RENESAS TECHNICAL UPDATE

| Product Category | MPU & MCU | | Document No. | TN-RL*-A038A/E | Rev. | 1.00 |
| Title | RL78/F13,F14 Restriction | | Information Category | Technical Notification | | |
| Applicable Products | RL78/F13,F14 Family R5F10Axx R5F10Bxx R5F10Pxx | Lot No | Reference Document | RL78/F13,F14 User's Manual: Hardware Rev.2.00 R01UH0368EJ0200 (May. 2014) | | |

Figure1. Behavior subject to the restriction

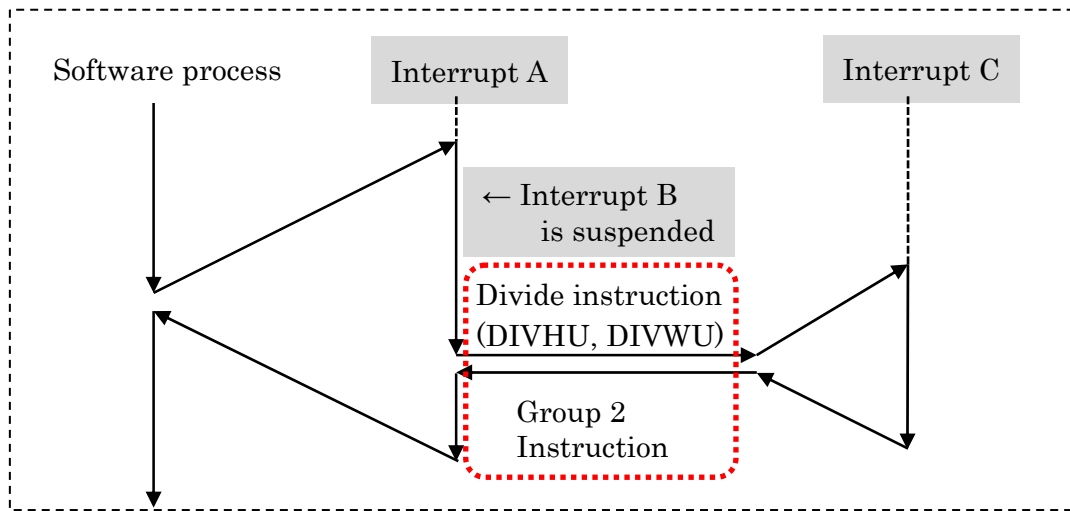
There is a possibility of unintended operation when branching from Interrupt A to Interrupt C, or branching from Interrupt C to Interrupt A.

- I. A "Group 1" instruction (DIVHU, DIVWU) and a "Group 2" instruction are consecutive in Interrupt A in which multiple interrupts are enabled.
- II. Interrupt B, whose request occurs during the process of Interrupt A, is suspended.
- III. Interrupt C is generated during the two clock cycles just before the MCU completes the execution of the divide instruction (8th or 9th cycle for DIVHU, 16th or 17th cycle for DIVWU).

Note 1: Please refer to Item 5. "The List of Group 2 Instruction" for the details of Group 2 instruction.

Note 2: Whether the MCU accepts an interrupt or not depends on the combination of the priority levels (0 to 3) of the interrupts. Table 1 shows the combinations subject to the restriction.

- (A) Disable interrupts during a divide or modulo operation.

- (B) Insert a NOP instruction immediately after the divide instruction.

Also, if the divide instruction (DIVHU or DIVWU) is executed in RAM, move it to code flash.
